Access Compliance Report

(Curb Ramps)

Intersection ID: 28526	Main Street: ROLLINGBROOK_DR	Cross Street: TYVOLA_CENTRE_DR	Location: NE
ADA ID: F01FAC0EBF6C	Ramp Type: Directional1	Initial Pass/Fail: Fail	Overall Compliance: No
Severity Score: 12.5			
Codes/Mitigation Info/Possible Solution		Field Measurements/Component Compliance

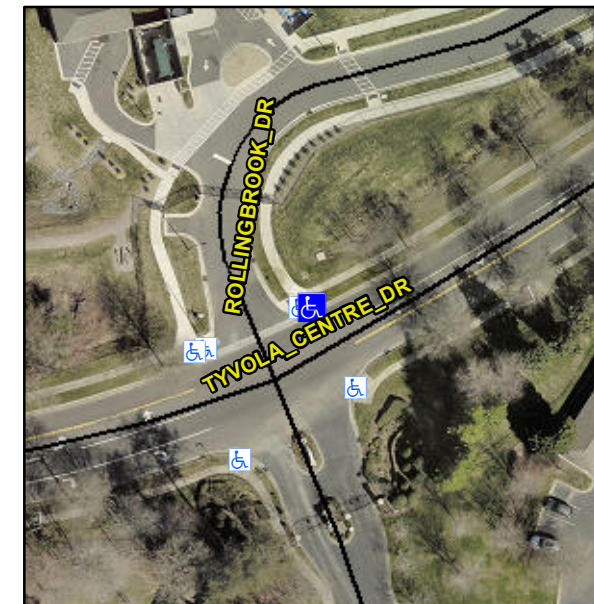
Remove & Replace Entire Ramp.

R304.2.2

Compliance	Description	Data	Compliance	Description	Data
N/A	Ramp Length (in)	57.0	N/A	Grade Break?	N/A
Yes	Ramp Width (in)	56.0	N/A	Grade Break Slope (%)	0.0
No	Ramp Slope (%)	8.9	N/A	Grade Break XSlope (%)	0.0
Yes	Ramp XSlope (%)	0.5			
N/A	Flare Type LT	N/A	N/A	Flare Type RT	N/A
N/A	Flare Slope LT (%)	N/A	N/A	Flare Slope RT (%)	0.0
N/A	Flare Traversable LT?	N/A	N/A	Flare Traversable RT?	N/A
N/A	Landing Length (in)	0.0	N/A	DWS Provided?	N/A
N/A	Landing Width (in)	0.0	N/A	DWS Contrast?	N/A
N/A	Landing Slope (%)	0.0	N/A	DWS Length (in)	N/A
N/A	Landing X Slope (%)	0.0	N/A	DWS Full Width?	N/A
N/A	Landing Curb? (Y/N)	N/A	N/A	DWS Offset LT (in)	N/A
N/A	Shared Landing?	N/A	N/A	DWS Offset RT (in)	N/A
N/A	Gutter Ponding?	0.0	N/A	Gutter Slope (%)	N/A
N/A	Gutter Lip Ht (in)	0.0	N/A	Gutter X Slope (%)	N/A
N/A	Painted X Walk1?	No		Road Slope (%)	4.1
	X Walk 1 Direction	To SE		Road X Slope (%)	1.6
	X Walk 1 Width (in)	N/A		Clear Space?	N/A
